**LEXINGTON-FAYETTE URBAN COUNTY GOVERNMENT  
CONTRACT CHANGE ORDER**

Date:	May 23, 2016
Project:	Public Safety Operations Center Phase 1B Renovation
Location:	115 Cisco Road
Contract No.	287-2014
Original Contract Amt.	\$6,109,000.00
Cumulative Amount of Previous Change Orders	\$540,661.24
Percent Change - Previous Change Orders	8.85%
Total Contract Amount Prior to this Change Order	\$6,649,661.24
Change Order No.	14

CHANGE ORDER: 14

**XE06**

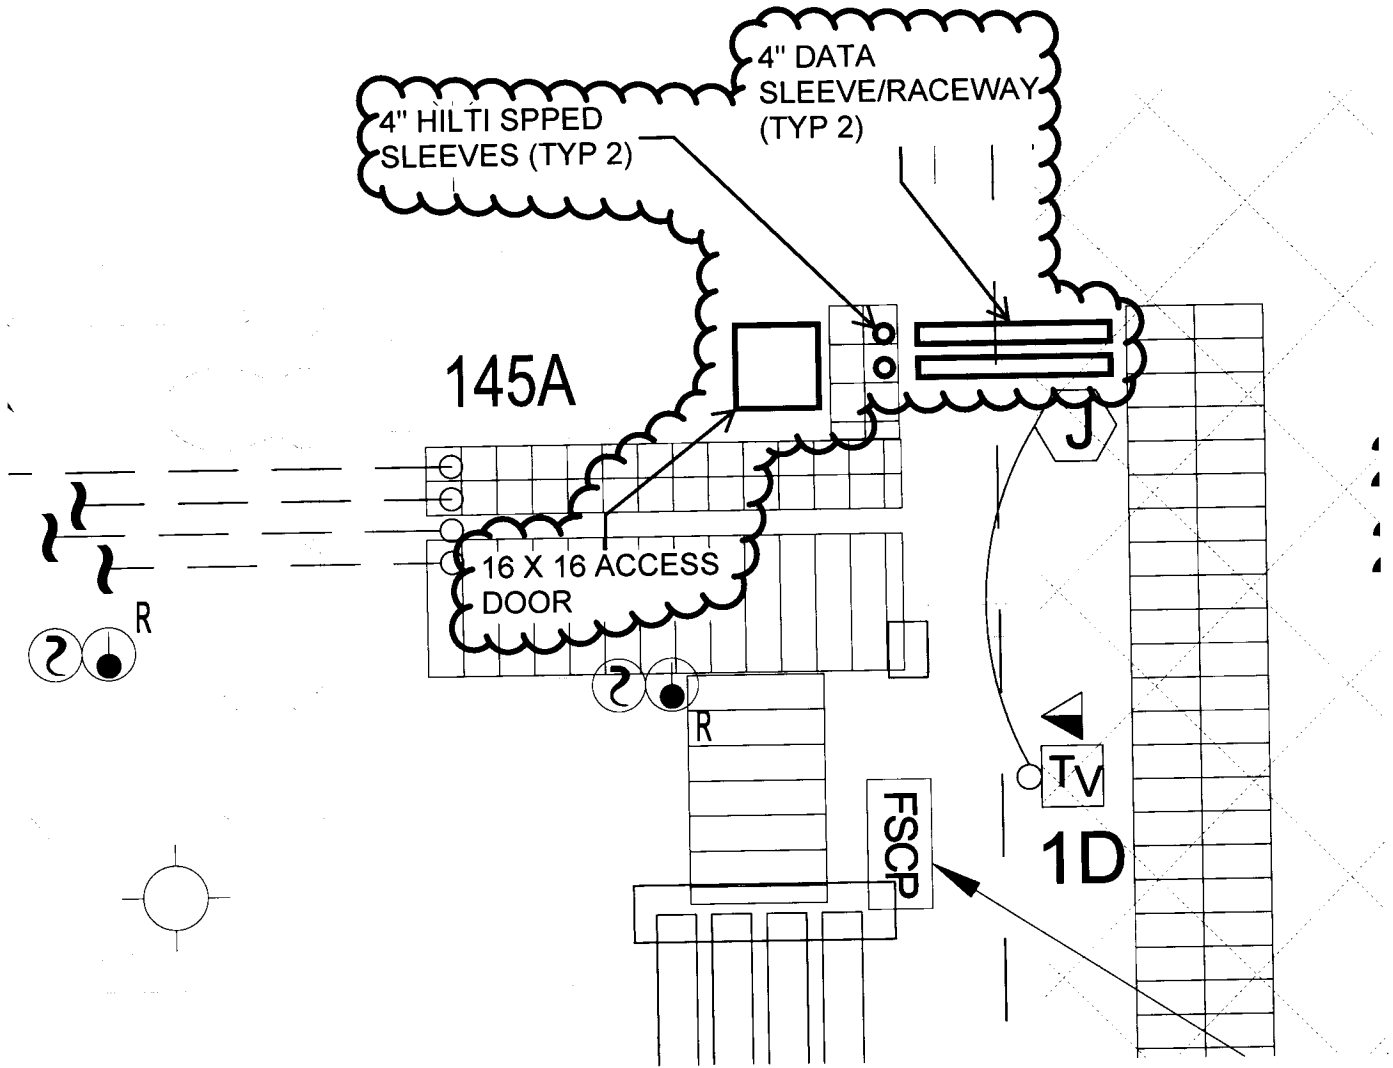
The Contractor shall provide a proposal to locate (1) 16" x 16" access panel as shown on Sketch XE06. Added access panel shall match, make and model of the adjacent access panel in IDF 145A. Exact placement shall be coordinated with all MPE systems and allow access to the (2) 4" sleeves/raceway connecting Phase 1B and Phase 2.

The Hilti speed sleeves specified shall be installed in the horizontal ceiling plane in line with the (2) 4" wall sleeves and above the cable tray as shown in Sketch XE06.

In ASI #33 we are instructed to install 2 hilti sleeves between rooms 145A and 144 for the communications cabling. we believe these should be installed in the drywall ceiling above room 145A as this is where they will be needed as this is the area that will need to be sealed prior oa the clean agent fire system activation. We also believe (at a minimum) a 16" X 16 " access panel needs to be installed adjacent to these to allow the cabling to be pulled and for any future work to be added. Please advise how to proceed.

ARCH. SUP. DWG  
**PR-55**  
**SKETCH**

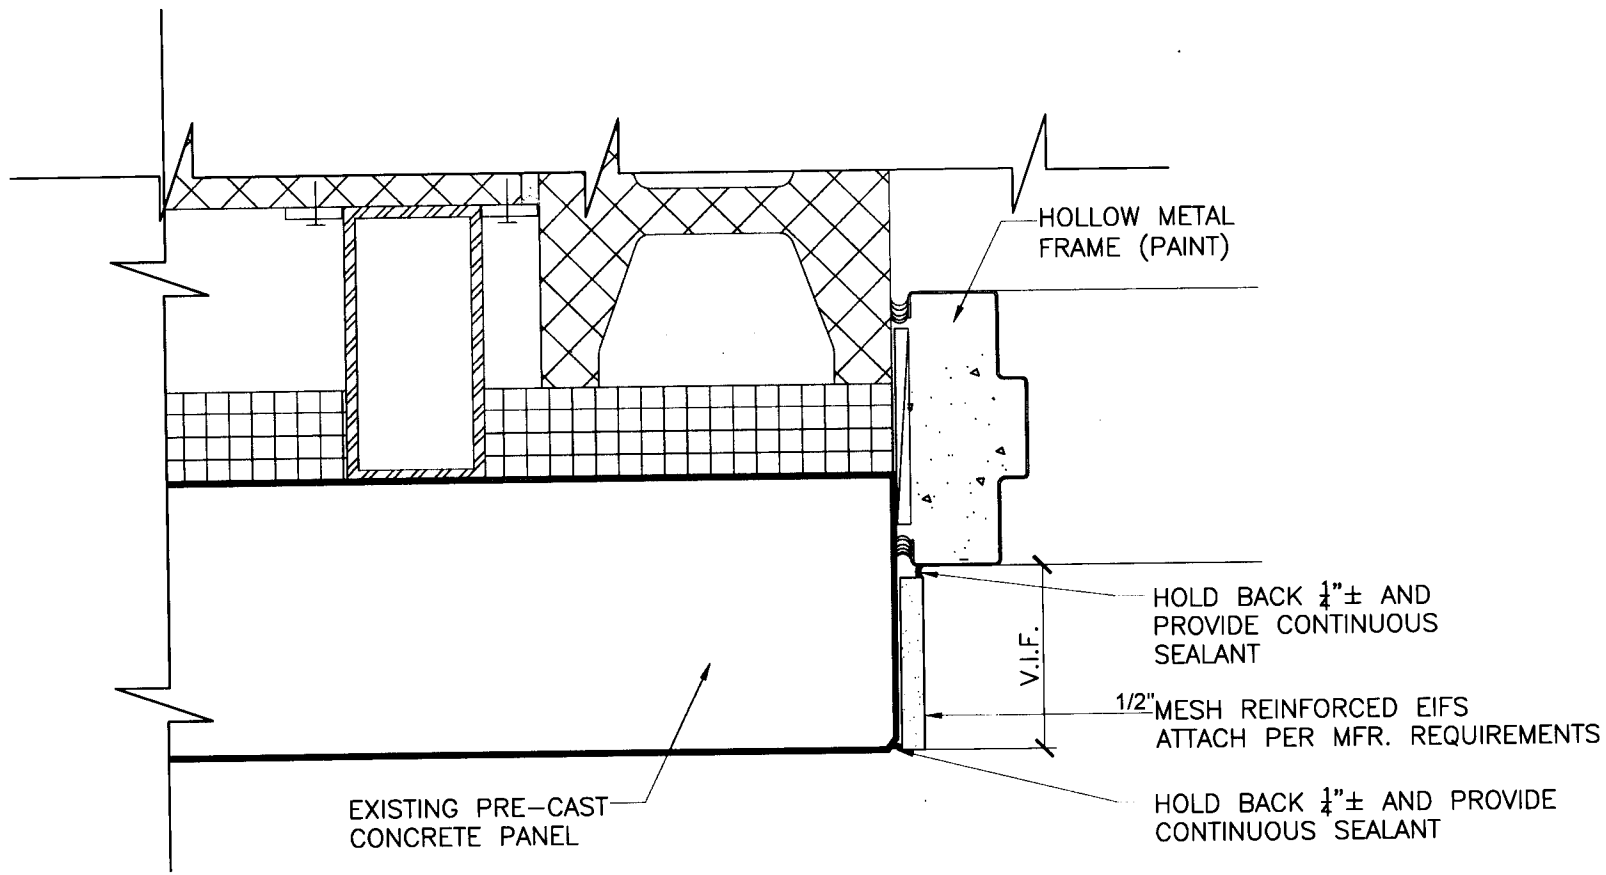
Contractor shall provide a proposal for the following scope of work at all openings that were cut into precast walls to receive HM frames. Contractor shall properly clean exposed rebar with a wire brush before applying one coat of Sherwin Williams Kemkromik (metal primer) to the areas where rebar is exposed in the openings. Contractor shall then apply a ½" Re-Enforced EIFS system to the face of the Head and Jamb of the opening as illustrated on the attached Sketch labeled PR # 55 Sketch.
